Access Compliance Report

Public Rights-of-Way

(Curb Ramps)

Intersection ID: 17733	Main Street: MANOR_RD	Cross Street: TRANQUIL_AV	Location: SE
ADA ID: 72443AFCA0FC	Ramp Type: PerpDiag	Initial Pass/Fail: Fail	Overall Compliance: No
		Severity Score: 55

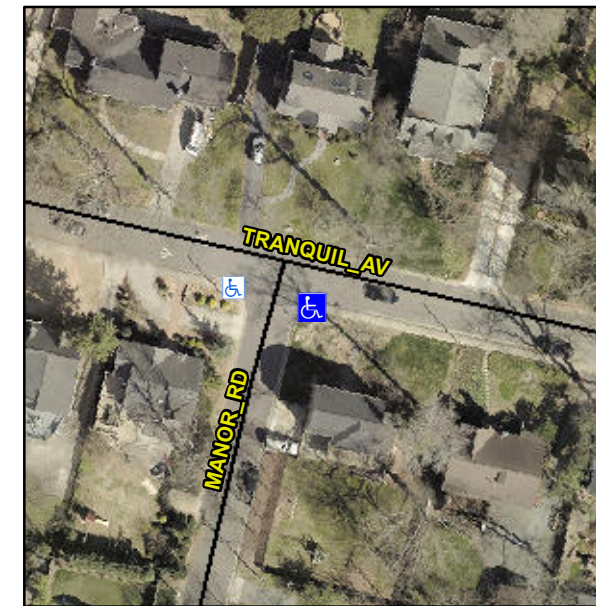
Not Found, R304.5.1, R304.2.2, R304.5.3

Compliance	Description	Data	Compliance	Description	Data
N/A	Ramp Length (in)	49.0	No	Ramp Slope (%)	11.1
No	Ramp Width (in)	34.0	No	Ramp XSlope (%)	15.8
N/A	Flare Type LT	N/A	N/A	Flare Type RT	N/A
N/A	Flare Slope LT (%)	N/A	N/A	Flare Slope RT (%)	N/A
N/A	Flare Traversable LT?	N/A	N/A	Flare Traversable RT?	N/A
N/A	Landing Length (in)	N/A	N/A	DWS Provided?	N/A
N/A	Landing Width (in)	N/A	N/A	DWS Contrast?	N/A
N/A	Landing Slope (%)	N/A	N/A	DWS Length (in)	N/A
N/A	Landing X Slope (%)	N/A	N/A	DWS Full Width?	N/A
N/A	Landing Curb? (Y/N)	N/A	N/A	DWS Offset (in)	N/A
N/A	Shared Landing?	N/A			
N/A	Gutter Ponding?	N/A	N/A	Gutter Slope (%)	N/A
N/A	Gutter Lip Ht (in)	N/A	N/A	Gutter X Slope (%)	N/A
N/A	Painted X Walk1?	No	N/A	Painted X Walk2?	No
	X Walk 1 Direction	To NE		X Walk 2 Direction	To NW
N/A	X Walk 1 Width (in)	N/A	N/A	X Walk 2 Width (in)	N/A
	X Walk 1 Slope (%)	15.6		X Walk 2 Slope (%)	1.7
	X Walk 1 X Slope (%)	0.2		X Walk 2 X Slope (%)	16.2

Remove & Replace Curb Ramp With Two New Directional Ramps or Equivalent.
